Re: **Rosebrook (PWS ID 0382010) Wellfield Improvements
Design Review #170093**

Subject: Rosebrook Water Company PWS 0382010
Wellfield Improvements (Phase 1 of the Pressure Reduction Project)
(Final) Design Review #170093

FIGURE 1
MODELED SYSTEM
PRESSURE
OPTION 1A

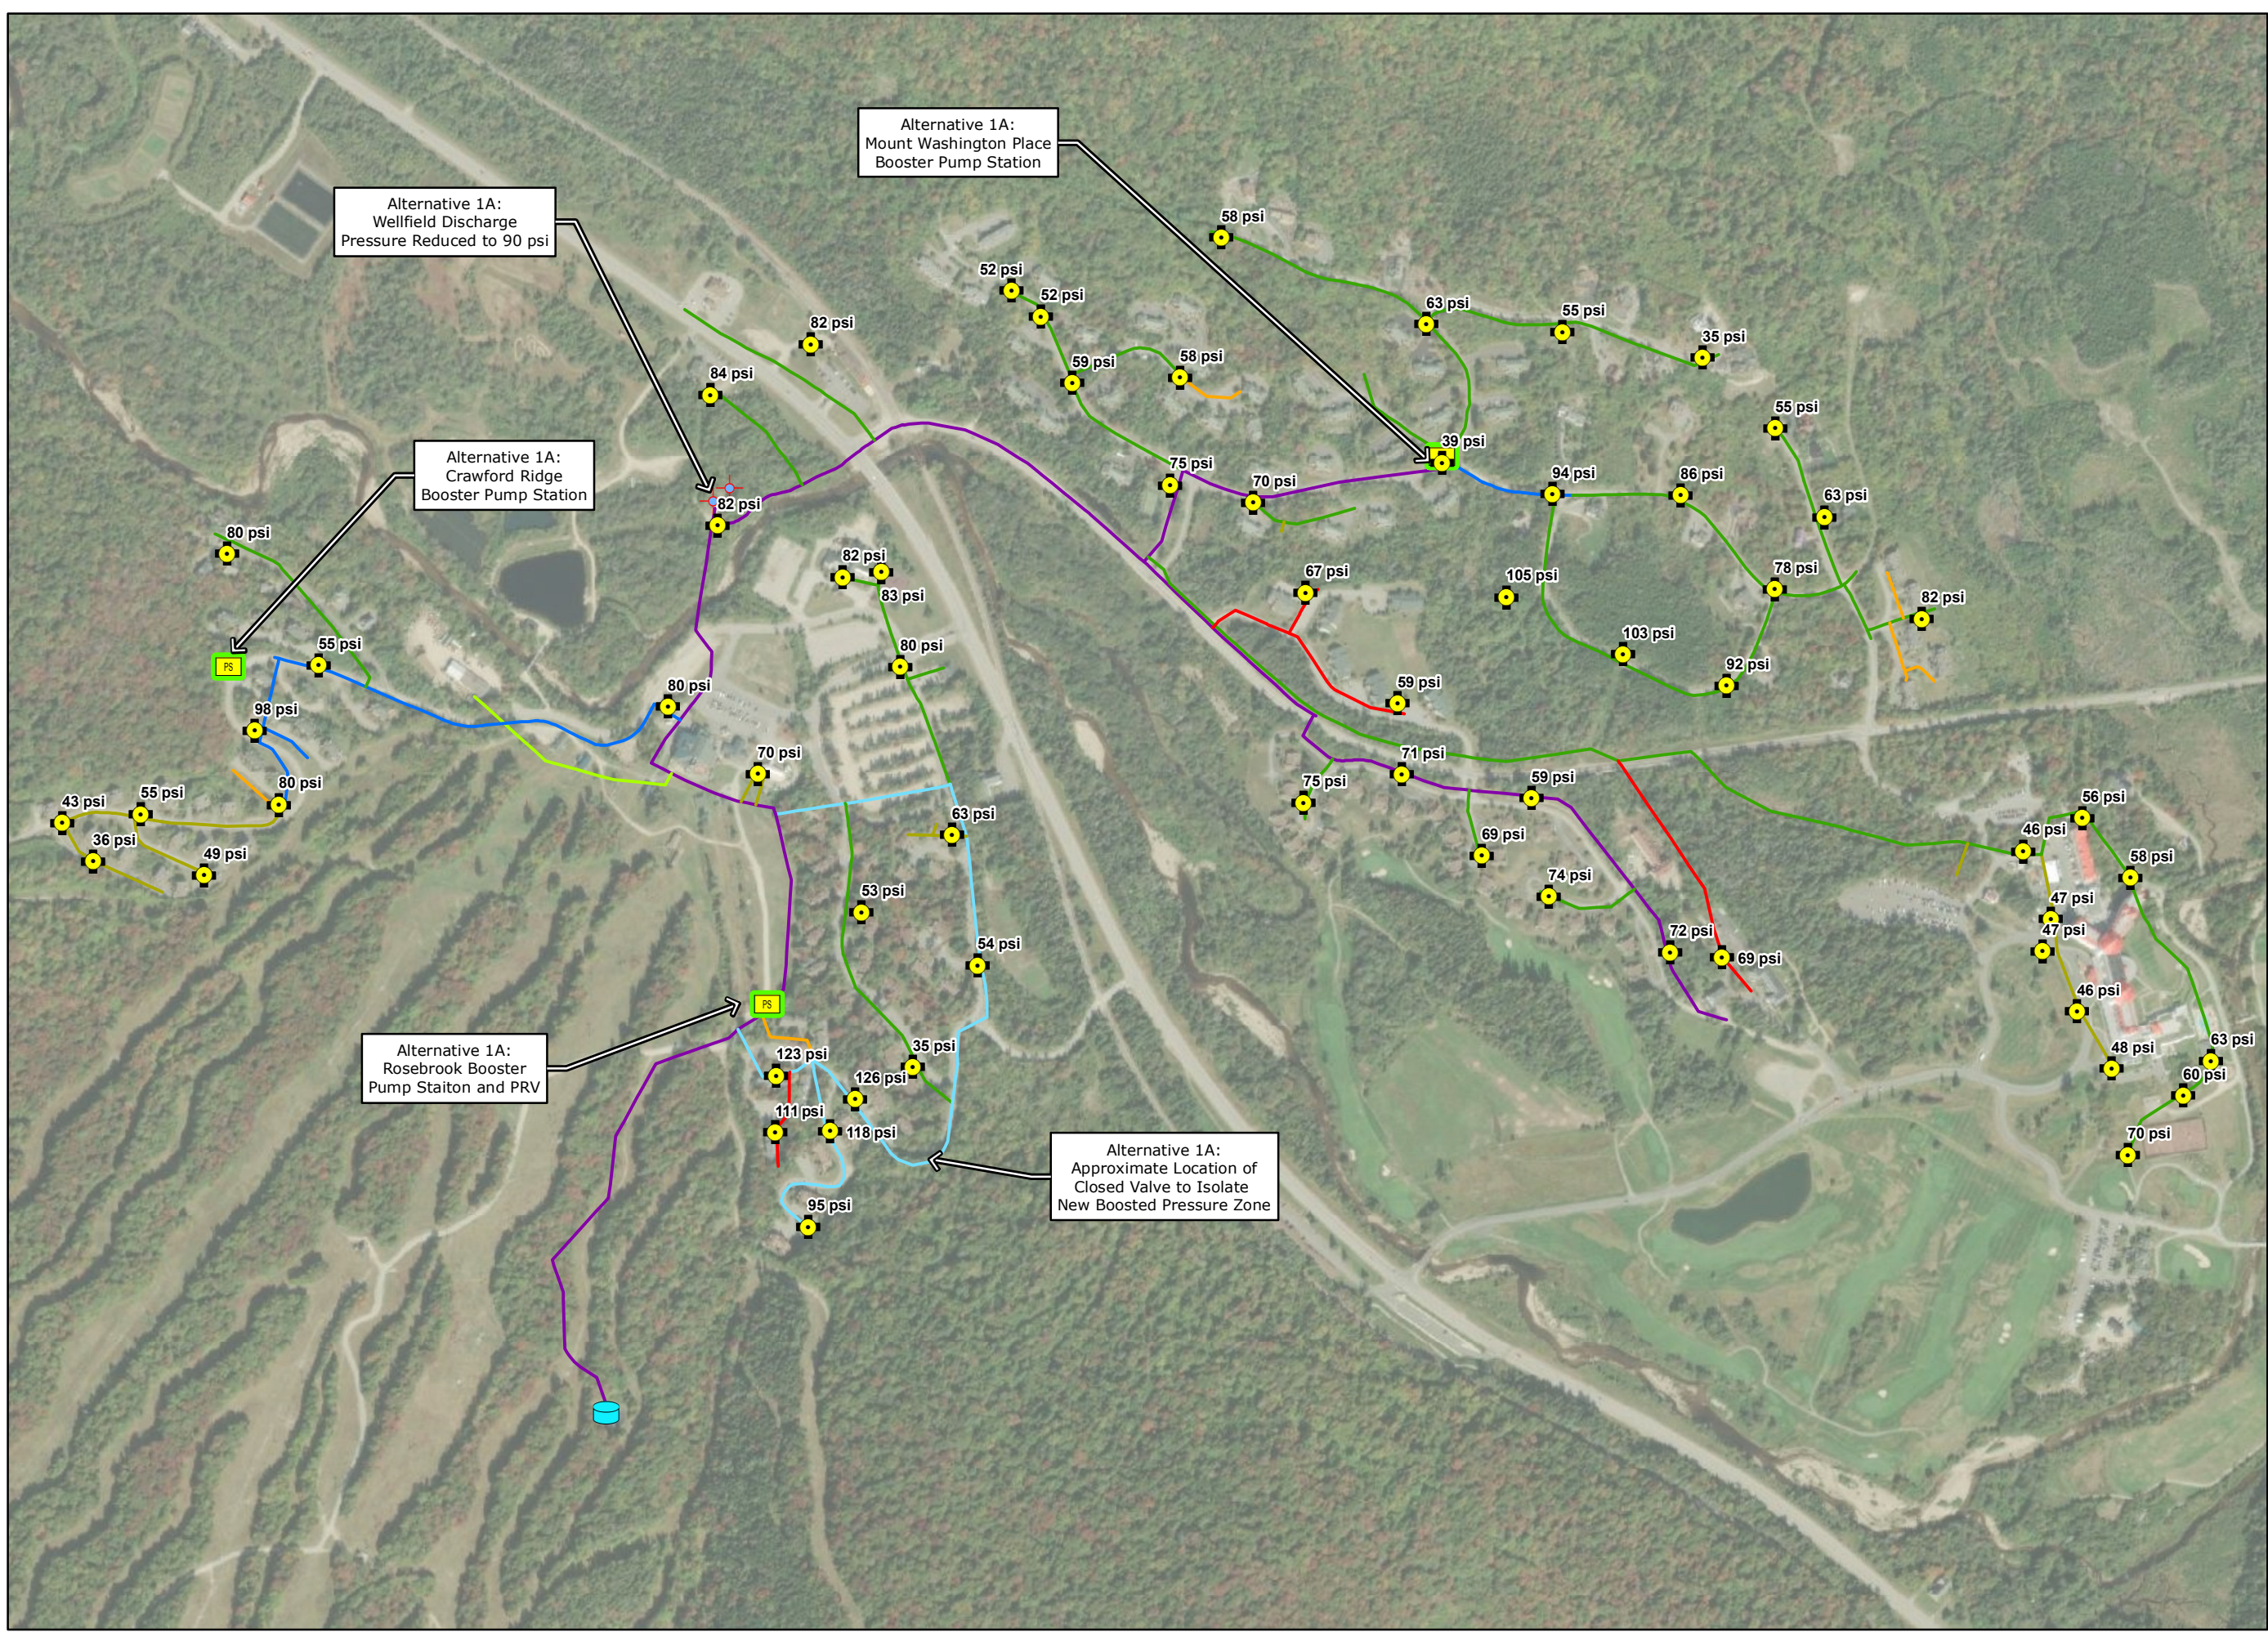
- 1. Provide an argument that the costs of Option 1A exceeds the benefit of reducing the pressures within the system to 100 psi, or other reasoning that Option 1A should not be selected over 4E, apart from maintaining existing pressure along the base road water service main.**

Option 1A would provide system-wide pressure reduction and generally maintain system pressure below 100 psi; however, it would not meet one of the project's primary objectives of maintaining domestic pressure and available fire flow at the Omni properties (Mount Washington Hotel, Bretton Arms, and Bretton Woods), as requested by Omni - the system's largest customer. In addition, other customers would experience a pressure drop of more than 50 psi, with some areas of the system experiencing 35 psi (See Figure 1 attached). This magnitude of pressure reduction is expected to result in complaints from customers across the system.

Option 1A would also provide less reliable service than Option 4E. The Crawford Ridge and Mount Washington Place pump stations required in Option 1A would pump out of the "closed" (i.e. no atmospheric storage) system created by the new Rosebrook Treatment Plant. Pumping into closed systems, particularly multiple closed system in series as required in Option 1A, increases the risk of distribution system and home plumbing damage related to water hammer. Closed systems are also inherently less reliable than systems with gravity storage, particularly for fire protection, because they rely on mechanical and electrical equipment and automated controls/communications. Even with standby power at each facility there will be short-term loss of service as the generators start-up following loss of street power.

Option 1A consists of upgrading the existing Rosebrook Wellfield to lower the wellfield discharge pressure, and adding three new pump stations and a new pressure reducing valve (PRV) to the distribution system. The expected capital cost for this option is \$6.35 million, including the estimated costs of easements for constructing each of the three pump stations. This option is almost \$2.5 million higher than the cost of the selected option 4E.

While the increased risk and reduced service described above are manageable, when combined with the significantly higher capital and operating costs, the "costs" of Option 1A are considered to exceed the benefit of additional pressure reduction.
